PREDEVELOPMENT PLAN REVIEW COMMENTS

Project Number: PPR2017-00017
Date: January 24, 2018
Project Address: 740-790 East Green Street

Review of preliminary plans for the establishment of a new Planned Development to allow the construction of a mix-use project with 273 residential units, 19,660 sq. ft. of commercial use, and a below grade parking garage with 453 parking spaces on a 101,650 sq. ft. (2.33 acre) project site.

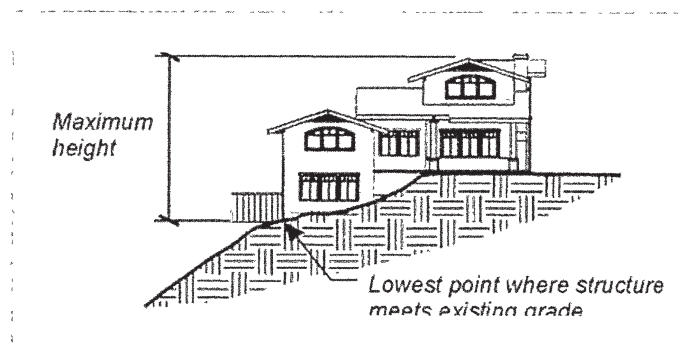
7 Floor Area Ratio (FAR) (PMC 17.26.020.C.3.c(1)): The FAR of a PD shall not exceed the FAR allowed on the Land Use Diagram for the project site unless approved by City Council, but only as high as 3.0, and only when it can be shown the architectural design of the PD is contextual and of a high-quality. The established FAR for the site, pursuant to PMC 17.30.040, Table 3-2, Figure 3-9 (Central District Maximum Floor Area Ratio), is 2.0.

The FAR indicated by the Land Use Diagram for the site is 0-2.25. The proposed total FAR is 3.0, therefore, the PD shall be reviewed by the Design Commission prior to consideration by the Planning Commission. The Design Commission shall advise the Commission and the Council as to whether the architectural design of the proposed PD is contextual and of high quality.

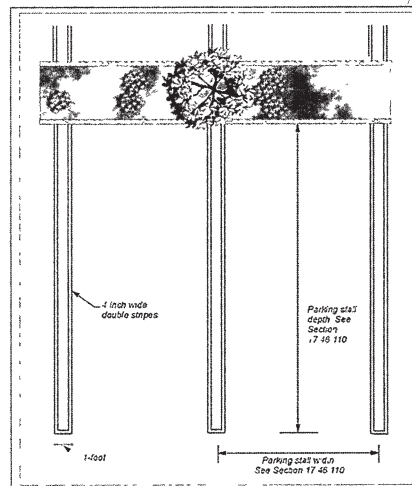
If parked for commercial uses (non administrative business professional offices and governmental office), the minimum required parking to be provided for the 19,734 square-foot of commercial space is a minimum of **47** parking spaces and a maximum of **53** parking spaces.

In addition, revise the Parking Calculation table so a specific land use is provided for the "Commercial" such as office, medical office, restaurant, retail, etc. Parking requirement will be based on the specific land use.
